B2961A-02

# Modification Recommended Service Note

B2961A 6.5 Digit Low Noise Power Source, 32W, 210V, 3A, 1ch

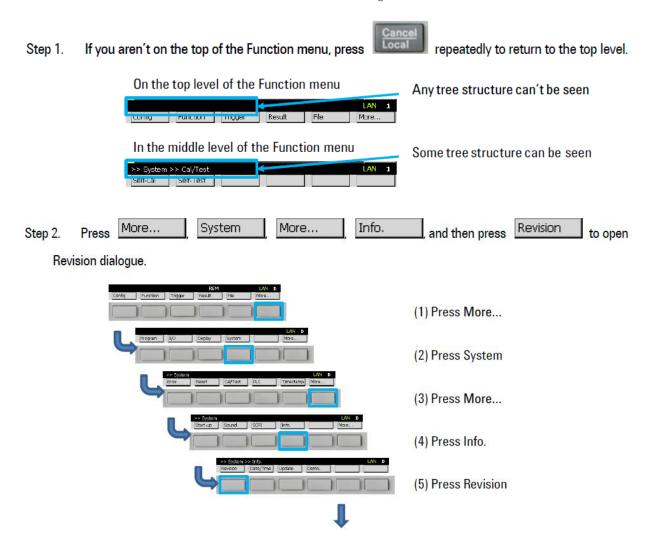
The B2961A with the following firmware revisions may have an internal communication error. This error may occur at the power on or when updating the firmware to the below revisions.

Firmware revision: 2.1.1645.5850 Firmware revision: 2.2.1744.8725

And it can be solved by installing the Firmware revision 2.2.1831.4380 or later.
